SERVICE NOTICE

To: All Leitner-Poma fixed grip chair customers 1981 to present.
Re: Bullwheel guide sheave brittle bars (derail switches)

LEITNER-POMA SERVICE BULLETIN

Re: Drive Bullwheel bushing and mounting hardware.

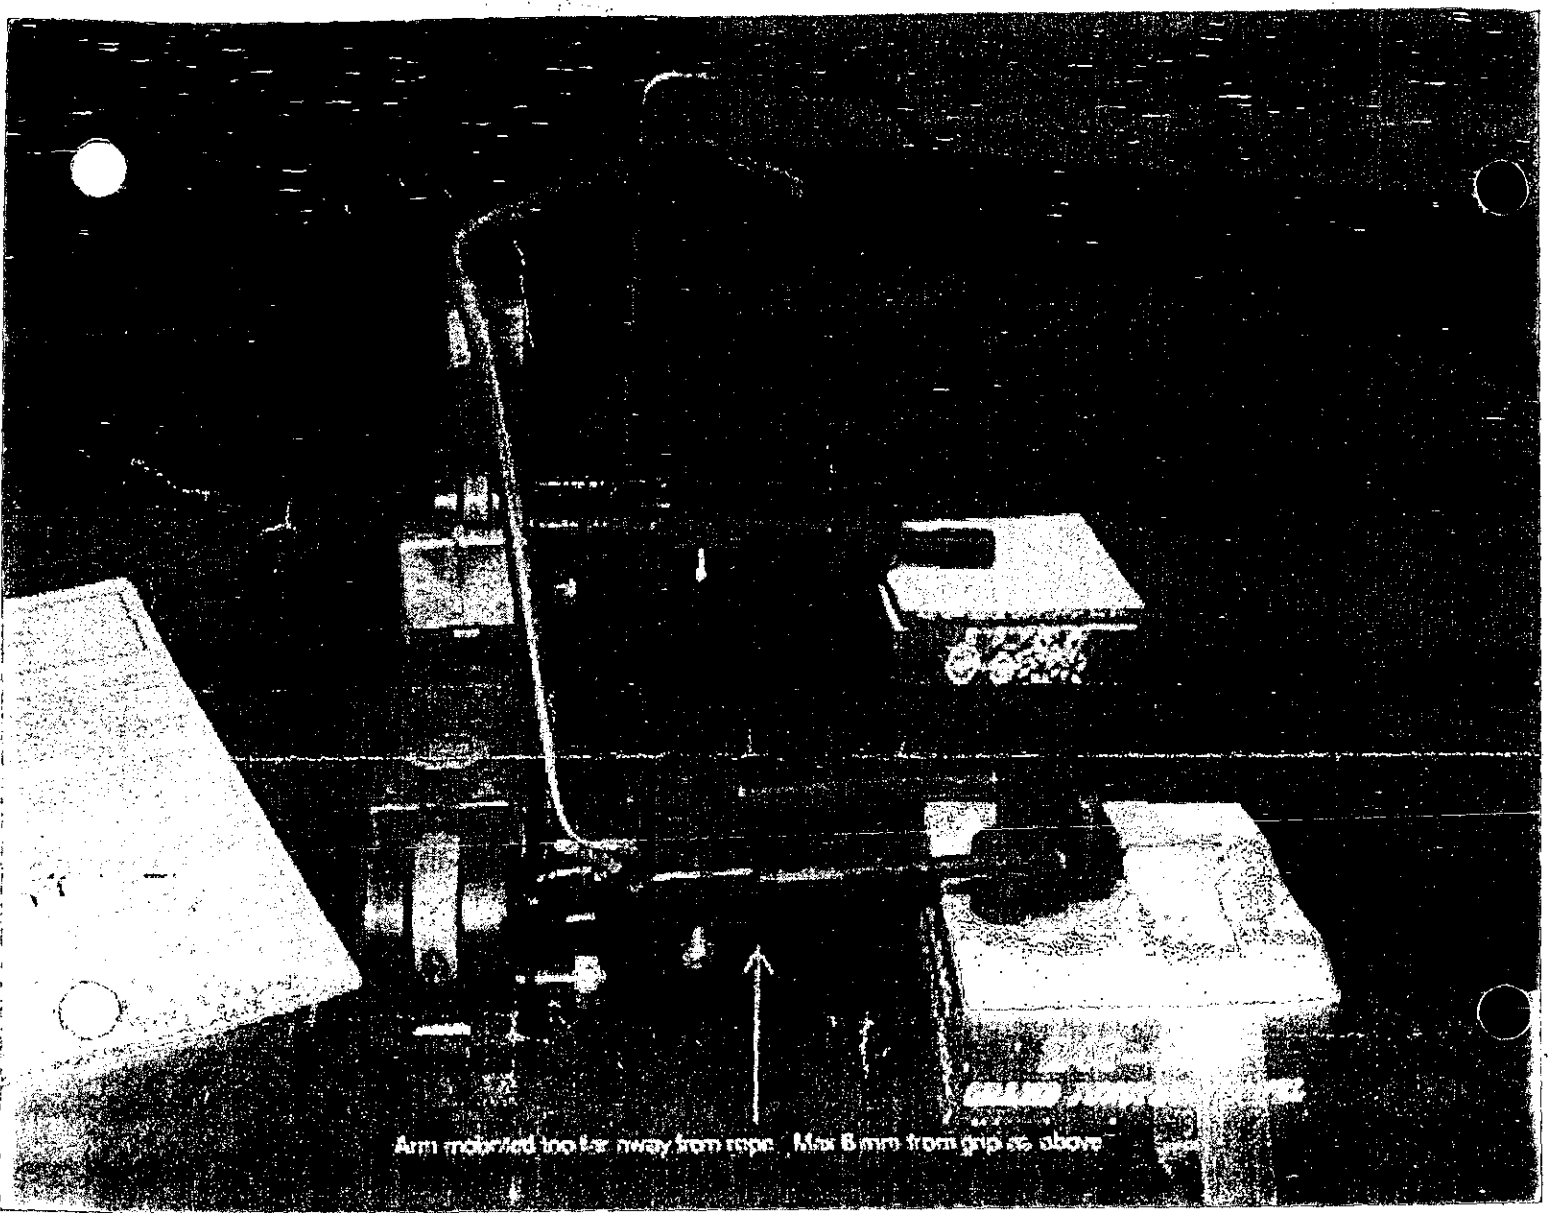
Accompanying this notice is a picture of the derail switch discussed. One shows the correct position of the hook, (back-ground), the other with the bent hook shows the hook positioned too close to the fracture notches (fore-ground).

Arm retracted too far away from rope. Max 5mm from grip as above

It is very important to verify the correct adjustment of the hook on your guide sheave brittle bars. The hooks should be positioned approximately half way between the fracture notches; the entire switch should then be adjusted in and out so the vertical arm of the hook is 6mm (+ or – 1mm) from the mobile jaw. The switch should then be adjusted vertically so the grip is centered in the opening between the end of the hook and the end of the brittle bar. Some subtle vertical adjustments may be necessary depending on loading or chair positions entering and exiting the bullwheels.

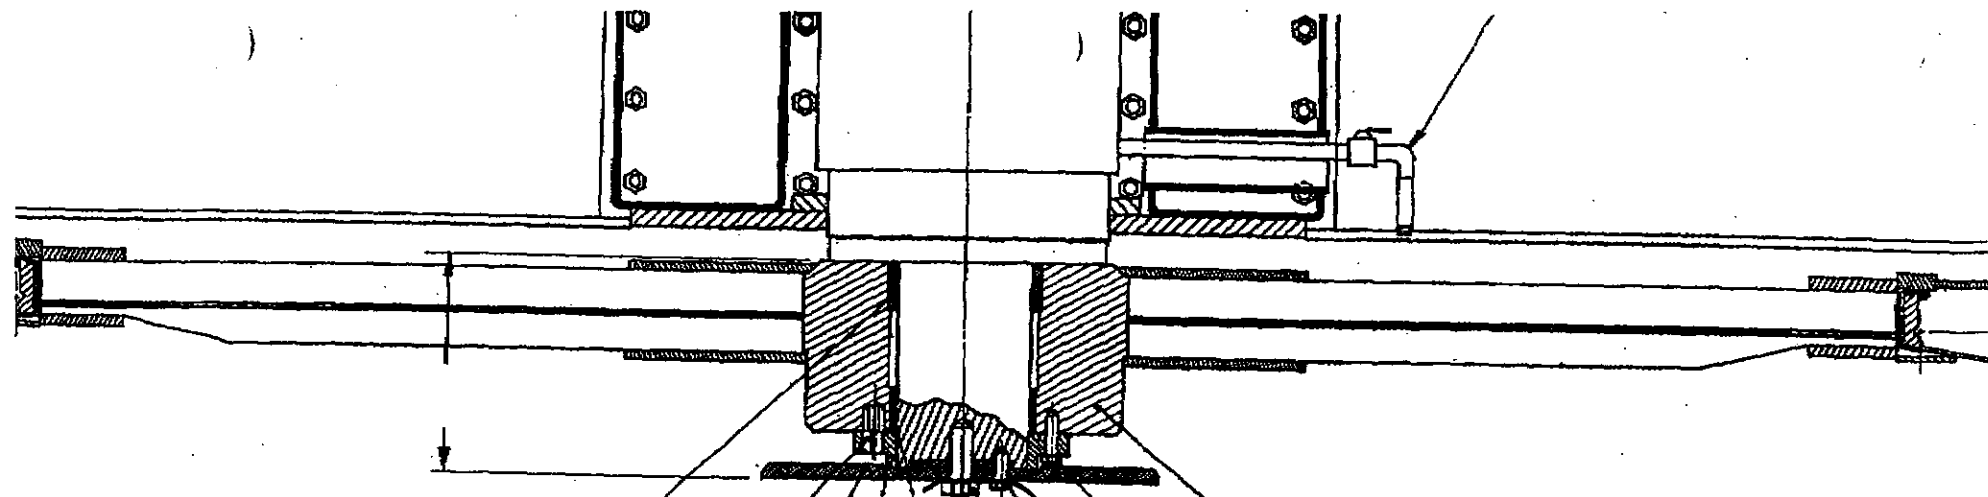
Over the past year we have seen an increase in the number of areas reporting significant wear of the cast iron bushings (I & H on accompanying drawing) in the drive bullwheels. Due to the nature of this mounting it is difficult to determine the extent of the wear without disassembly of the bullwheel. In most cases, the problem did not become apparent until one of the bolts that mount the cable catcher/retaining plate to the shaft was broke. In some cases the wear was discovered when the mounting bolts were found to be loose, or the head of a bolt broke when it was tightened.

Leitner-Poma requests that you check the tightness of the 3-M20 (DD) and the 1-M36 (AA) bolts that mounts the cable catcher/retaining plate (G) to the output shaft. The following procedure for tightening the bolts is recommended.

- Tighten the 3-M20 (DD) bolts to a torque value of 140 ft/lbs.
- Tighten the M36 (AA) bolt to 360 ft/lbs.
- Run the lift for at least 10 revolutions of the bullwheel.
- Repeat this sequence at least 3 times, or until the heads of the bolts no longer turn at the specified torque values.
- After approximately 50 hours of normal operation, check the tightness of the bolts again.

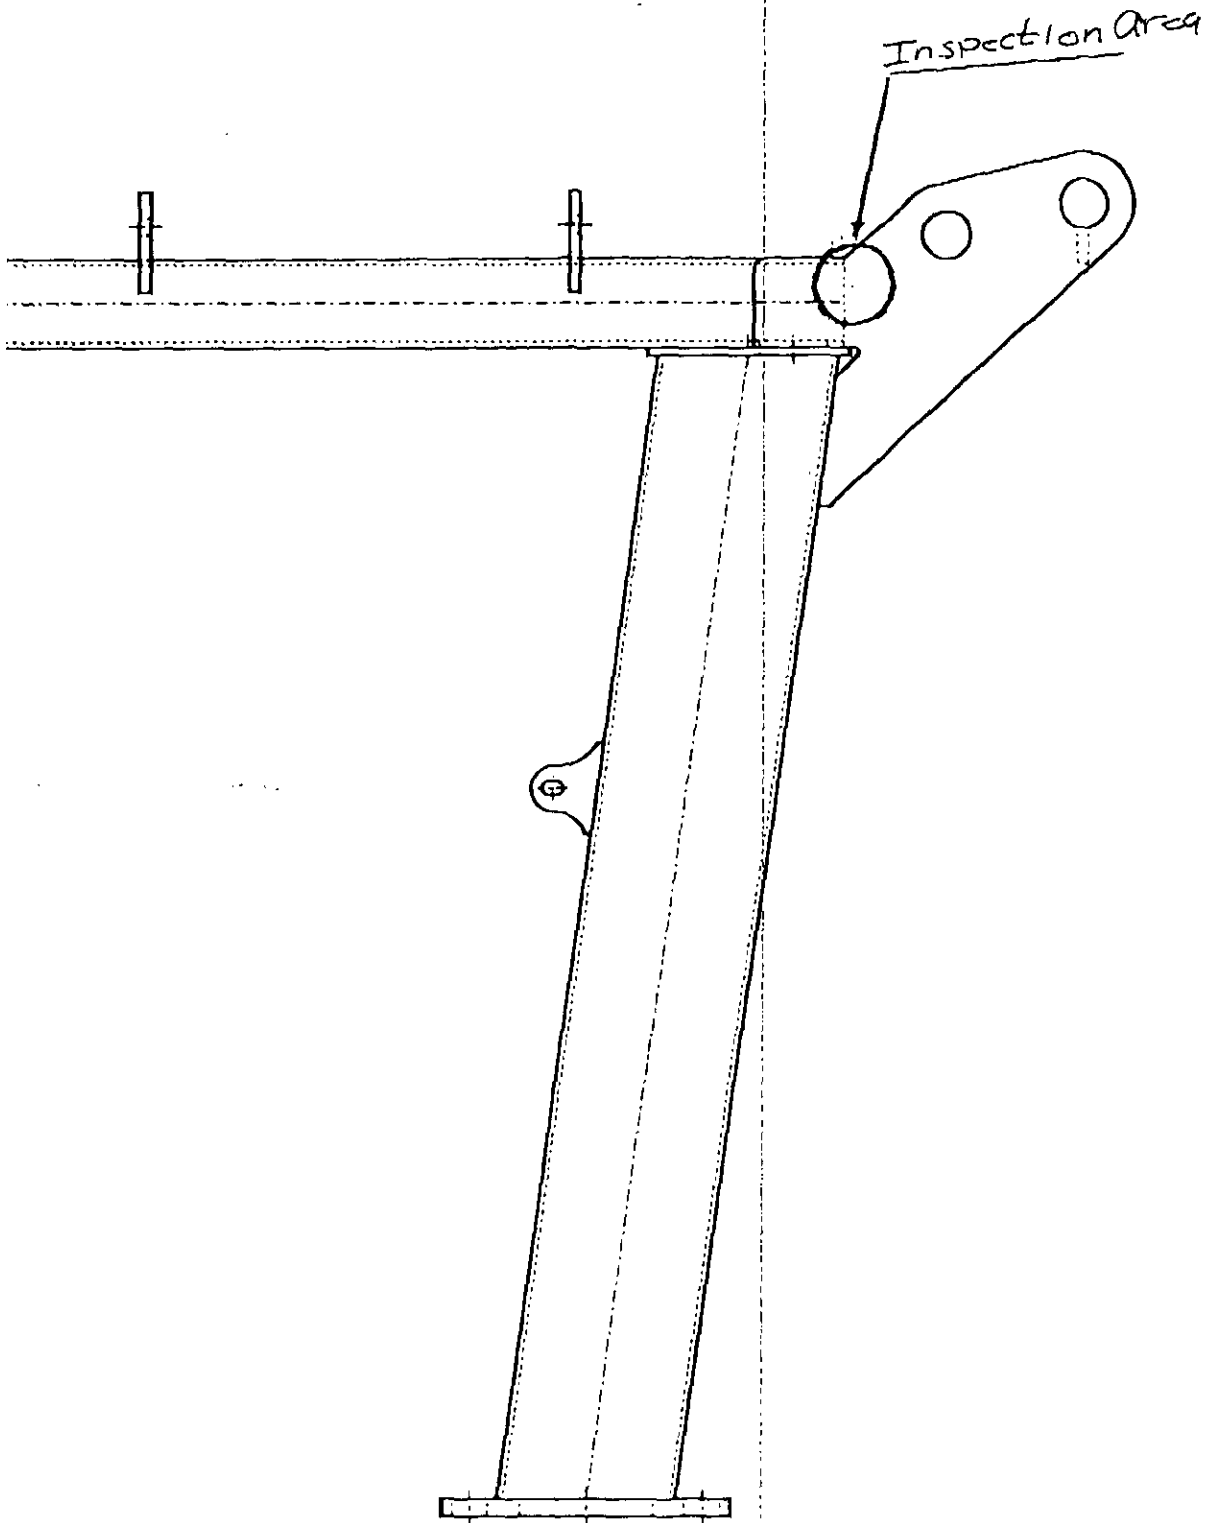
L-POA has been informed of cracks found in the rigging flanges.

L-POA is requesting that you perform a visual inspection of the area noted on the accompanying drawing. This inspection should be performed on 100% of the crossarms of lifts installed in 2001, 2002 and 2003.
